Access Compliance Report

Public Rights-of-Way

(Curb Ramps)

Intersection ID: 28511	Main Street: BRAY_DR	Cross Street: HOLLY_PARK_DR	Location: W
ADA ID: F8A72B294754	Ramp Type: BlendTrans2	Initial Pass/Fail: Fail	Overall Compliance: No
Severity Score: 42.5			
Codes/Mitigation Info/Possible Solution		Field Measurements/Component Compliance

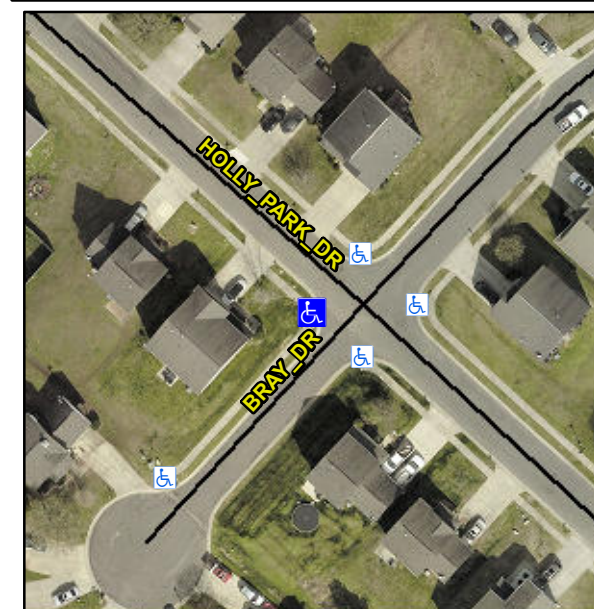
DAMAGED GTR

Not Found, R304.5.1, R304.5.3

Remove & Replace Curb Ramp With Two New Directional Ramps or Equivalent.
